AURIX™ TC37x errata sheet

Marking/Step: (E)ES-AA, AA

About this document

Figure 14 Positive overload on P-pad of a LVDS RX pin pair (both used as inputs)

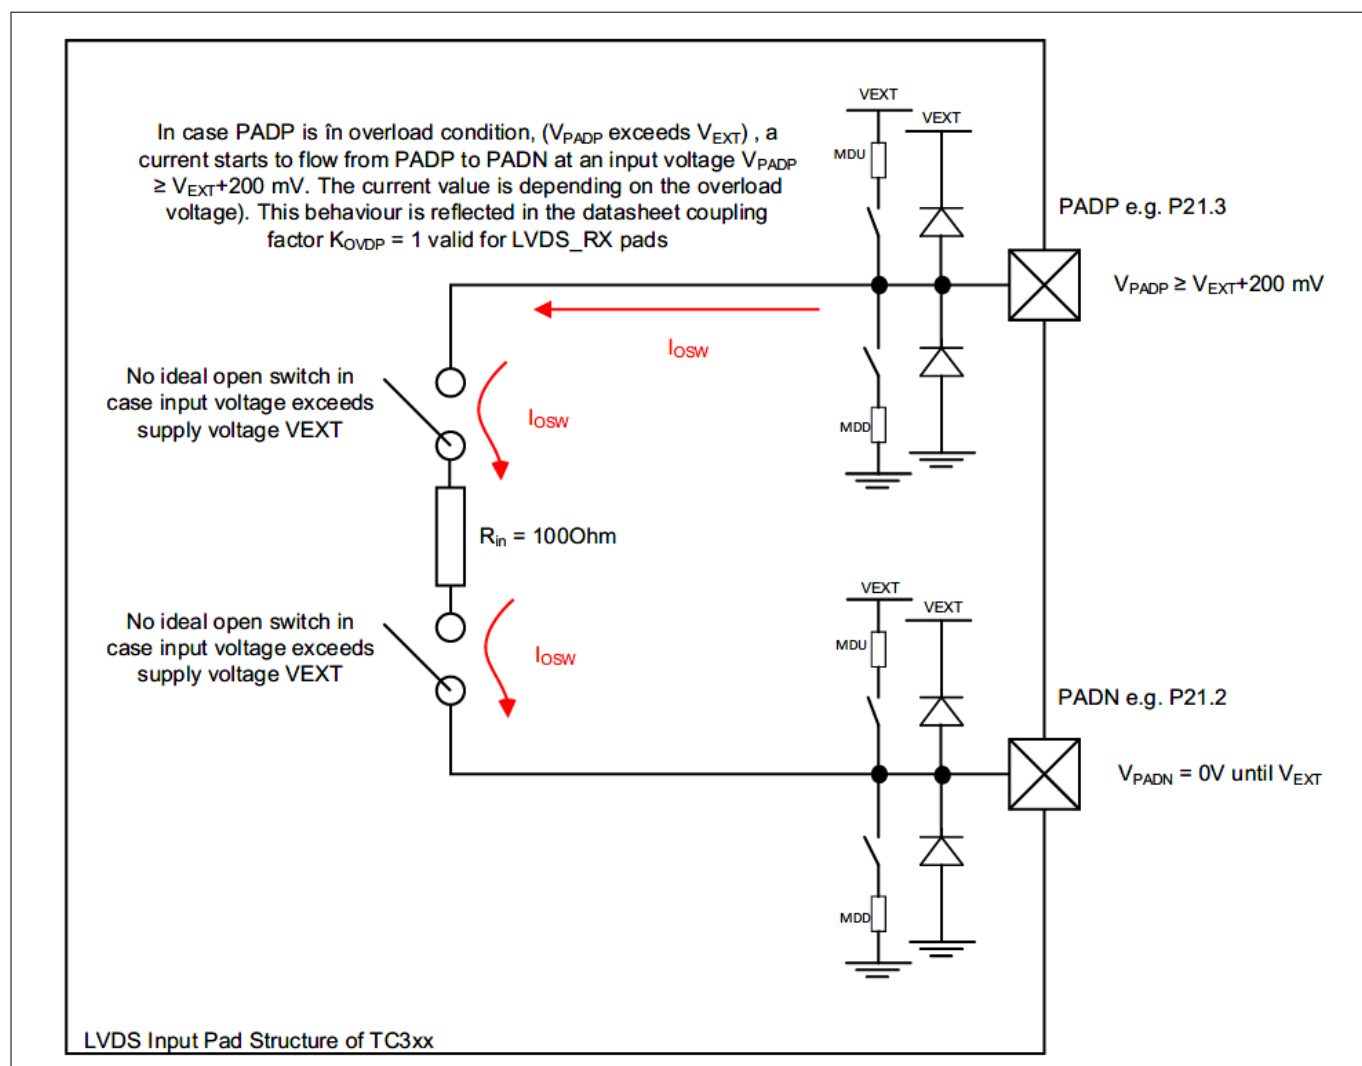
The overload current I_{OSW} through the non-ideal open switch significantly increases when $V_{PADP} \geq V_{EXT} + 200 \text{ mV}$.

Note: In general, the effect will also occur if the N-pad is used as output, or for a negative overload condition on either the P-pad or the N-pad.
